From: Grant, David
Sent: 26 July 2019 14:04
To: _planningadvice
Subject: FW: West of Bank House Farm H19-0953-18 & H19-0954-18
Attachments: We sent you safe versions of your files; 2032 M PRICE NEW HOUSE FLOOR PLAN INDICATING SERVICE ENTRY Model (1).pdf; 2032 M PRICE NEW HOUSE GAS MEMBRANE DPM DETAIL Model (1).pdf

From: David Broker [mailto:david.broker@btinternet.com]
Sent: 26 July 2019 12:09
To: Grant, David
Subject: RE: West of Bank House Farm H19-0953-18 & H19-0954-18

From: Armour, Susan [mailto:Susan.Armour@Breckland-Shollandgov.uk]
Sent: 08 July 2019 12:12
To: Grant, David
Subject: RE: West of Bank House Farm H19-0953-18 & H19-0954-18

GROUND FLOOR PLAN

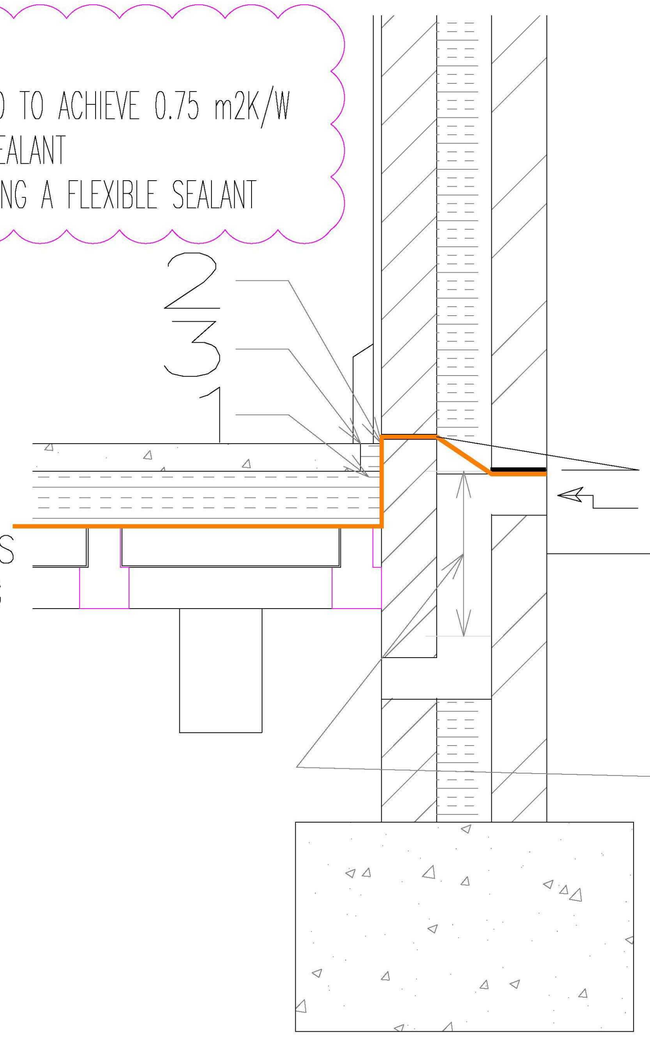
That membrane and jointing tape conform to BS8485:2015 so will be fine in this situation, however we do need to see how they are proposing to install it – for example the architects/ structural engineers drawings which so the cavity, and how the membrane is joined to the dpc, what happens around any service pipes etc. I have had a quick look at the manufacturers website and it doesn't give any standard details that I can refer to instead.

Electric meter and Communications access

Dear David,
I have been on Holiday thus the delay.
In response to Susan Armours question.
The Membrane is supplied in 4m widths, 2 joints across the floor area are required which will be sealed by manufacturers sealing Tape.
The Membrane is linked/lapped beneath the dpc to the inner leaf of blockwork. The membrane will then also form a Cavity tray and be linked the outer leaf of Brickwork. As indicated on the attached plan.
There will be no perforations through the Membrane as all service entries and Soil Stacks are positioned outside the building. As the attached plan.
